Supplement for comment #41, 42, 43, 44

Akio Tajima

Green Platforms Research Labs., NEC Corporation

1000GBASE-PX40, 10GBASE-PRX/PR-40 with PBEx

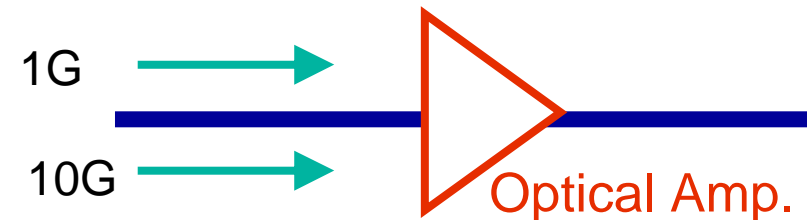
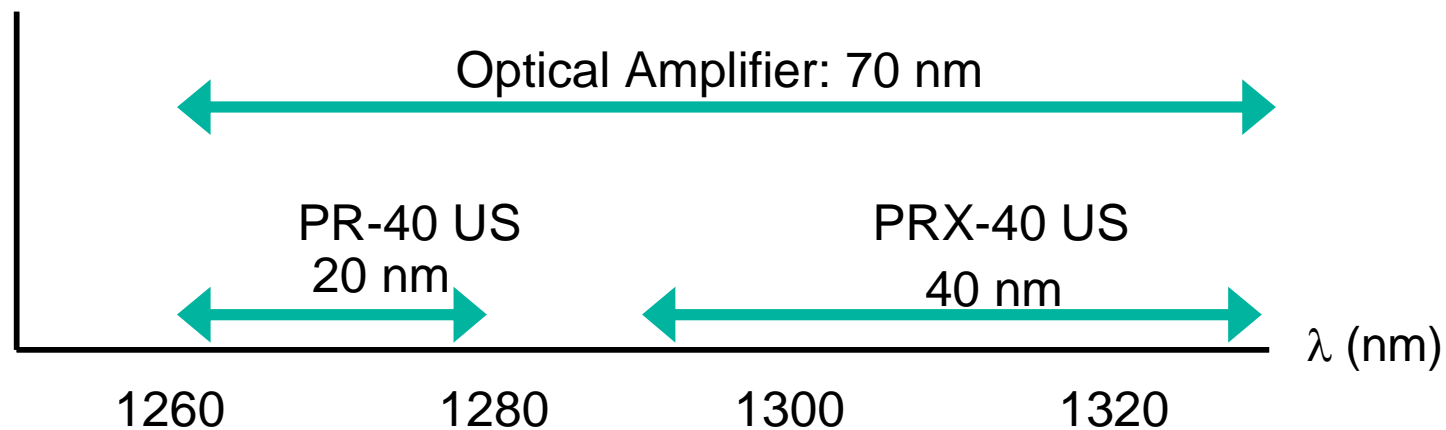
In case of coexistence 1G and 10G, one OA should amplify both 1G and 10G optical signals. In D1.0, optical transmitter wavelength range are;

- 1260 to 1280 nm for 10G
- 1290 to 1330 nm for 1G

Wavelength bandwidth of 1260 to 1330 nm (70 nm) is required to OA and it is difficult to realize good performance OA with wide wavelength bandwidth such as 70 nm.

- Optical transmitter wavelength range of 1290-1330 nm cannot be realized with FP-LD.
- If the wavelength of 1G upstream is narrowed as 1290-1310 nm, wavelength bandwidth can be narrowed as 1290 to 1310 nm (50 nm). It is easier to realize than D1.0.
- Therefore, the wavelength range of 1000BASE-PX40-U in Table 75-1 shall be narrow as 1300 +/-10 nm.
